AW1600 Version 1.1 Manual Update

This AW1600 firmware update adds the following features.

New Feature: Track Edit MERGE Command (Manual page 135)

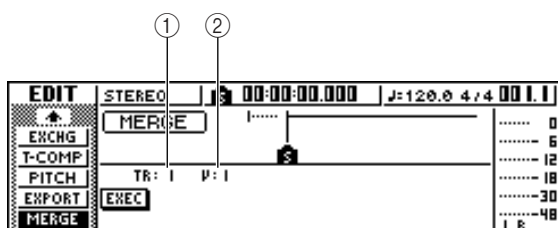
A MERGE track edit command has been added to enhance the unit's audio playback performance.

Audio playback performance can be improved by using this command to merge a number of separate regions (sections of audio data created in separate recording passes) in a specified track into one continuous region.

The merge command creates a continuous region from the beginning of the track to the end of the last region on the track, and sections of the track that contained no regions are replaced with audio silence.
